Ref. ID ADHOC-D-26-02099
"Onset-Anchored Selective Computation for Resource-Constrained Vehicular Edge Networks"
(submitted as "Trustworthy Selective Computation for Resource-Constrained Vehicular Edge Networks"; retitled in this revision, see R3.7)

Response to Reviewers*

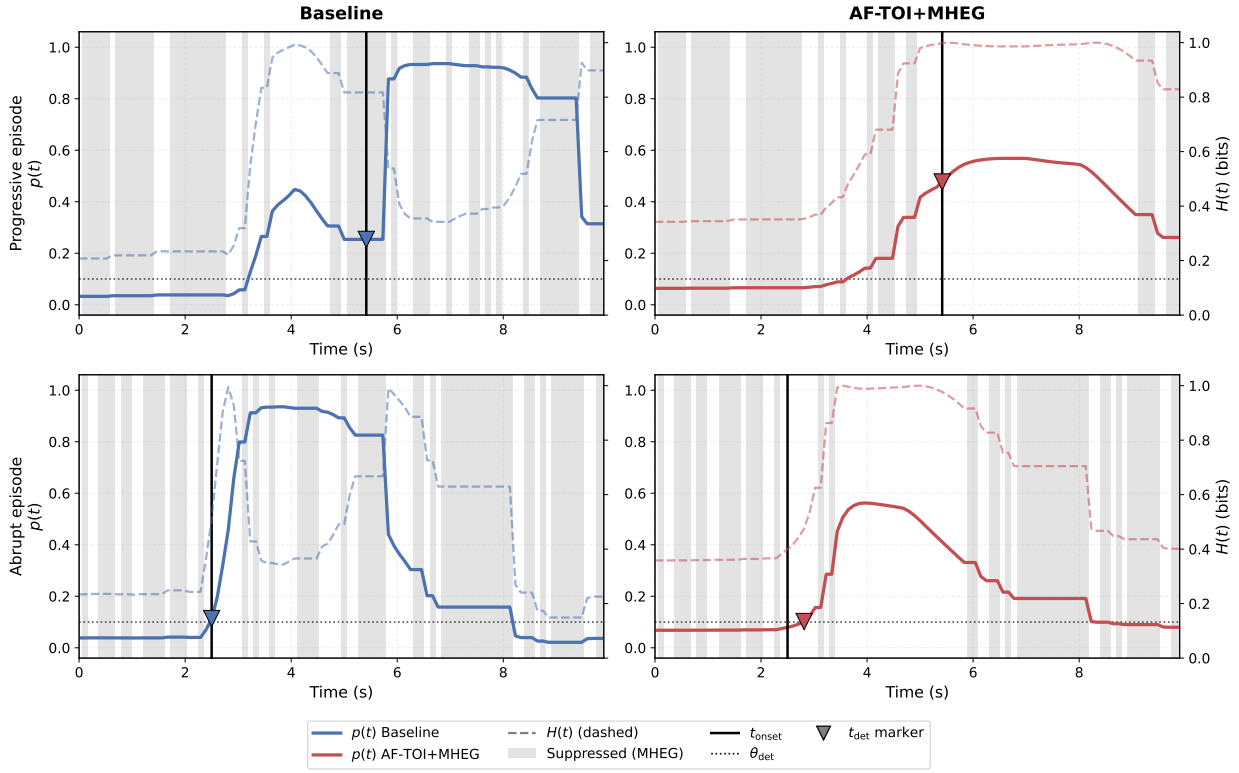
6. Comment: Frame-by-frame temporal evidence for seed 42 graph is not explained well.

Response: We agree with the reviewer. A frame-by-frame reading guide has been added to the paragraph following the first mention of Figure 5 in Section 4.2, identifying each visual element of the seed-42 examples. During revision verification we also found and corrected two problems in this figure: (a) the exemplar episodes of the submitted version were not selected by a stated criterion, and the abrupt exemplar was atypical (it belongs to a saturated minority of episodes whose entropy sits near the maximum throughout); the figure now uses, per regime, the episode with the *median* pre/post-onset entropy contrast among seed-42 critical episodes with central onset, and the caption states the criterion; (b) the replay that produced the suppression shading applied the entropy threshold in the wrong logarithm base (natural log instead of the base-2 entropy of Eq. 11), so the entropic branch of the gate never fired in that log; the log was regenerated with the correct base, and the entropy axes of Figures 4–6 are now uniformly in bits, matching Eq. 11. The added

(The full frame-by-frame reading guide follows the first mention of Figure 5 in Section 4.2.) Its selection criterion reads: "The exemplars are selected by a pre-declared neutral criterion: within each regime, the episode whose pre/post-onset entropy contrast is the *median* among the critical episodes of seed 42 with a centrally located onset (progressive: episode 36, t_0=5.42 s; abrupt: episode 148, t_0=2.50 s)." The guide also states that detection markers of single exemplars do not arbitrate latency (aggregate latencies are settled by Table 8) and that a minority of abrupt critical episodes (12 of 48 in seed 42) runs near maximal entropy throughout. The regenerated figure is reproduced below.

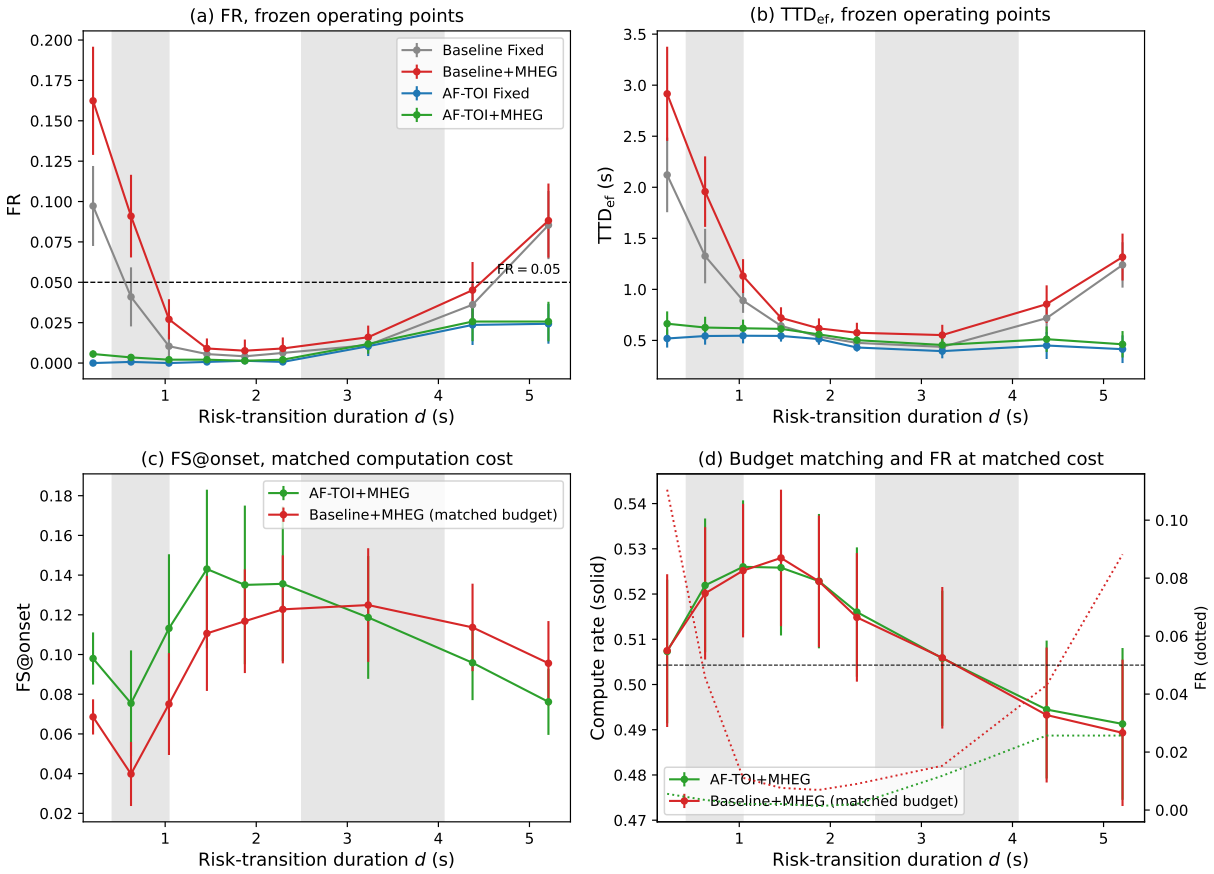
4. Comment: A central claim of the study is that temporal organization of uncertainty is important for safe selective computation, but the current experiments appear to be strongly tied to the risk-transition patterns defined by the experimental setup. The authors should investigate whether AF-TOI generalizes to unseen temporal risk trajectories, different onset durations, abrupt versus gradual transitions, intermediate-risk conditions, changes in the distribution of input features, or distribution shifts between training and testing conditions.

Response: We agree with the reviewer. To address the question of generalization across different transition durations, a new temporal-scale experiment has been added in Section 4.12, together with Figure 14 and Table 21. The experiment varies the risk-transition duration independently through a shape-preserving temporal warp while keeping t_0, the normalized transition shape, the episode context, the model weights, and the scheduler thresholds fixed. The limitations paragraph of Section 5 was also revised to distinguish this controlled temporal train–test shift from broader naturalistic distribution shift. The six aspects raised in the comment are addressed as follows.

"Figure 14a–b and Table 21 report the frozen operating points. AF-TOI maintains mean FR below 0.05 at every evaluated duration (maximum duration-wise mean 0.026), and $\mathrm{TTD}_{\mathrm{ef}}$ stays within approximately 0.40–0.66 s. The Baseline crosses mean FR = 0.05 at both extrapolation extremes (mean FR 0.097 at 0.21 s and 0.085 at 5.21 s for the fixed policy), and its $\mathrm{TTD}_{\mathrm{ef}}$ follows a U-shaped profile that reaches 2.12 s at the fast extreme. At the level of individual seed×duration cells, AF-TOI exceeds FR = 0.05 in 7 of 108 cells (all at $d \geq 3.23$ s, maximum 0.108), against 22 of 108 for the fixed Baseline (maximum 0.250) and 32 of 108 for Baseline+MHEG (maximum 0.333). Frame-level F1 remained seed-sensitive under the warp, a pattern consistent with checkpoint-level variability rather than with an effect of the warp itself. Accordingly, the result is restricted to aggregate coverage and effective delay and does not constitute a per-seed guarantee: AF-TOI shows aggregate temporal-scale robustness across the evaluated synthetic range of unseen risk-transition durations." (Section 4.12, second paragraph)

"Because the two frozen gates suppress different fractions of frames, we added a post-hoc matched-budget diagnostic: for each seed×duration cell, the entropy threshold of Baseline+MHEG was adjusted by bisection (...) until its computation rate (fraction of executed window updates; both arms share the recompute semantics of Section 3.4) matched that of AF-TOI+MHEG on the same cell (all 108 cells matched within 1.9%, tolerance 2%; Figure 14d). (...) At matched computation cost, no systematic FS@onset advantage remains (...). Under Holm correction within each endpoint family, only the $\mathrm{TTD}_{\mathrm{ef}}$ difference at 0.21 s remains significant ($p = 0.031$), so these per-duration matched-cost contrasts should be read as exploratory. The matched-budget diagnostic supports a temporal-scale coverage-and-timeliness advantage, not a universal improvement in near-onset suppression placement." (Section 4.12, third paragraph)
